PRE-APPLICATION COMMENT SUMMARY LETTER

SUBJECT: Summary of Comments and Questions
Major Development Pre-Application Public Workshop on September 25, 2025
480 Avenue Alhambra, El Granada, CA 94019
APNs: 047-251-100, 047-251-110, and 047-262-010
County File Number: PRE2025-00033

Subject: ***Pre-Application PRE2025-00033 (Granada Community Park and Recreation Center Project)***

Snapshot (1)

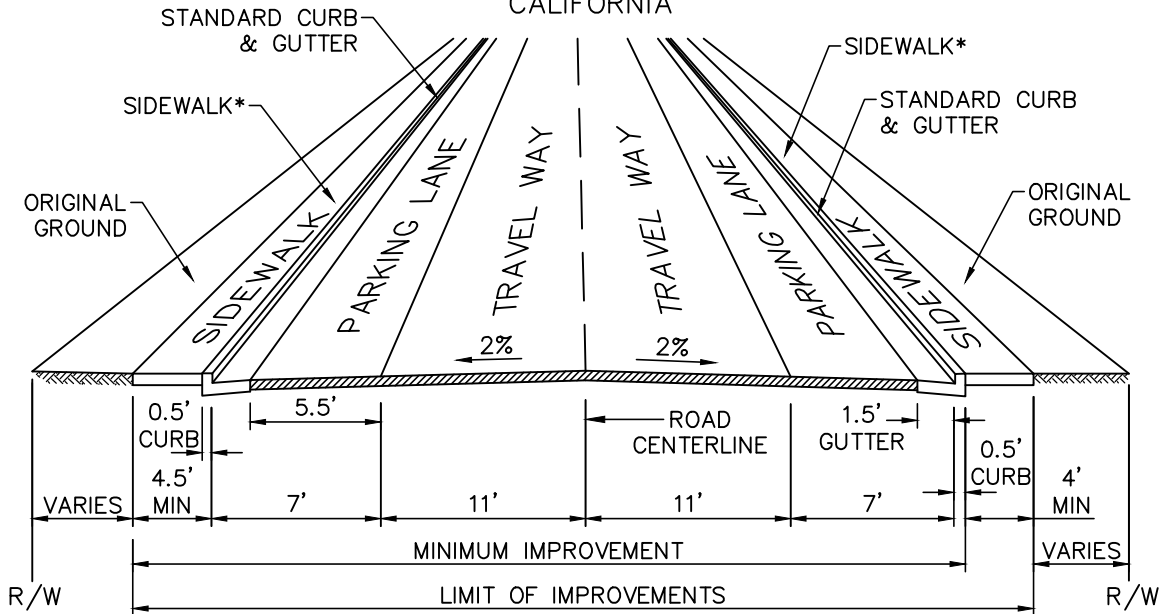
El Granada road standards require 22' paved travel way, parking lane, curb, gutter, and sidewalk. See attached detail
